UNITED STATES PATENT AND TRADEMARK OFFICE

APPLICATION NO.	FILING DATE	FIRST NAMED INVENTOR	ATTORNEY DOCKET NO.	CONFIRMATION NO.
09/609,163	06/30/2000	Robert E. Fischell	JNJ3-00	2477

Office Action Summary

DETAILED ACTION

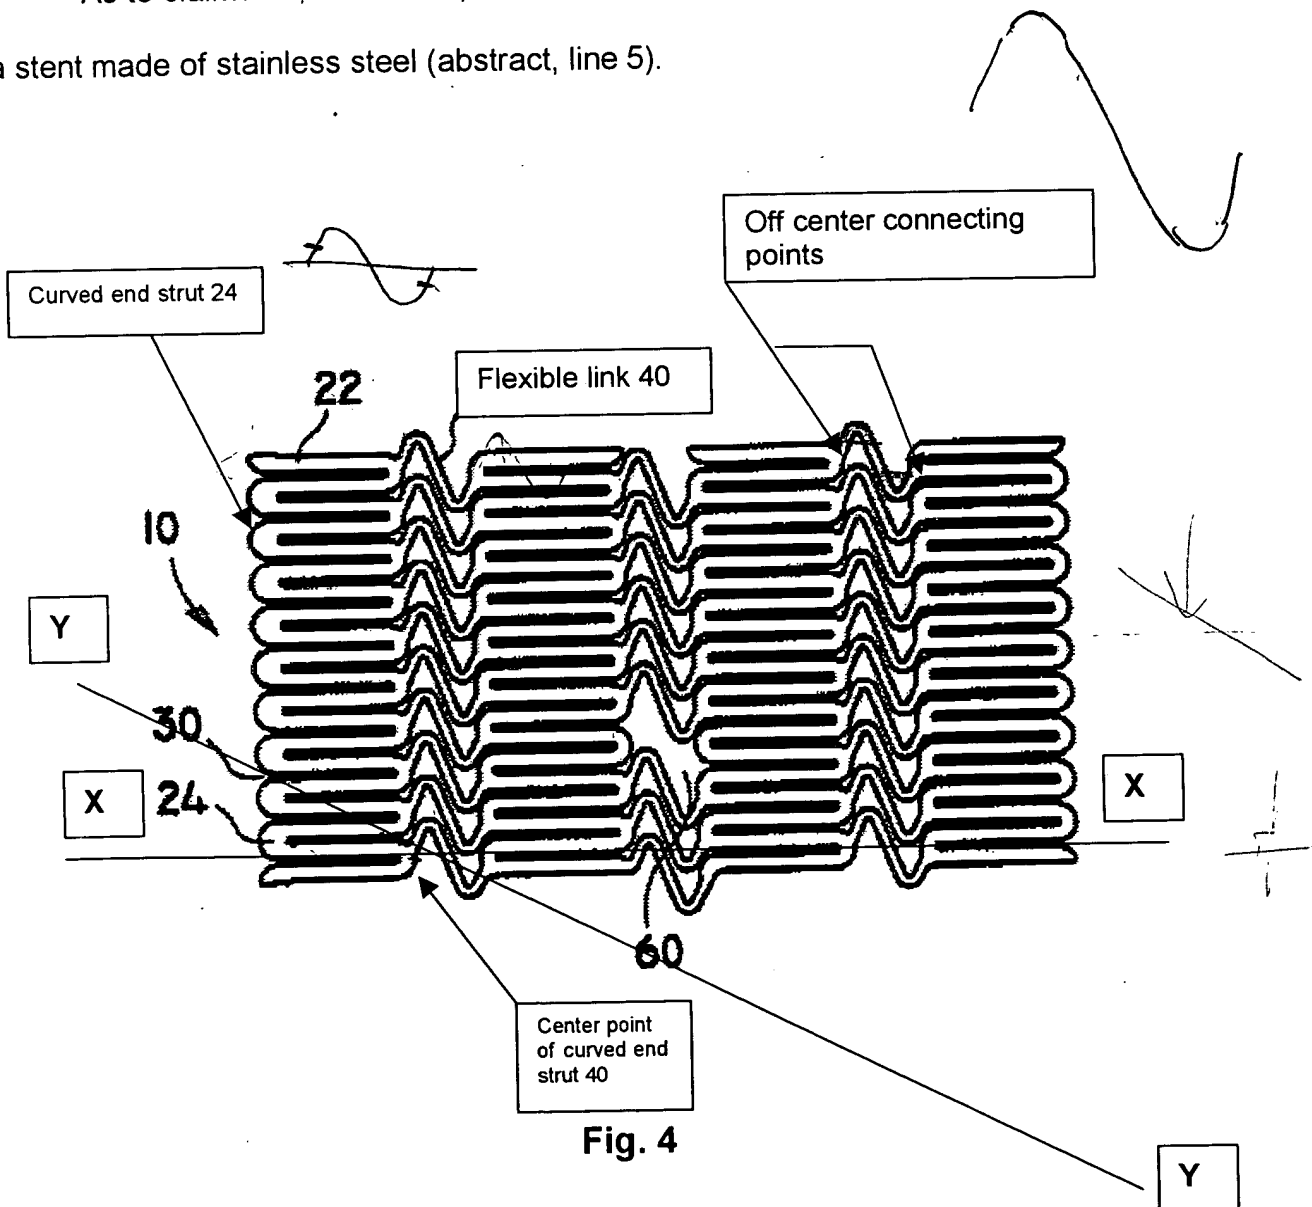
As to claims 50, 53 and 54, HESS et al reference (Fig. 4 shown below) discloses a stent made of stainless steel (abstract, line 5).

The stent illustrated in Fig. 1-4 includes curved end struts 24 connected to associate curved end struts 24 by flexible links/wavy strips 40. **The connecting point of each flexible link/wavy strip to a curved end strut 24 is offset from the center point of the curved end strut 24.** HESS (Figs. 1-4) discloses that the flexible links/wavy strips connected to the curved end struts 24 as shown would at least provide greater axial flexibility for the stent and large perimeter side openings 50 for a side branching blood vessel access (lines 1-11, page 9). Although each flexible link/wavy strips 40 (as shown in Fig. 1-4) does not include at least four curved segments connected together in series by three generally circumferentially extending segments of approximately equal length as claimed, attention is directed to HESS et al reference (page 11, lines 10-14). The HESS reference discloses that the flexible links 40 can have various configurations such as a sine wave shown in Fig. 12a-b having one or more repeating portions 102. In view of these explicit teachings, it would have been obvious to one of ordinary skill in the art at the time the invention was made to modify the flexible link 40 illustrated in Fig. 4 to have at least four curved segments being connected together in series by three generally circumferentially extending segments of approximately equal length as claimed, which would form N-shaped flexible links, for this configuration would provide an axial flexibility to the device and large openings 50 for a side branching blood vessel access.
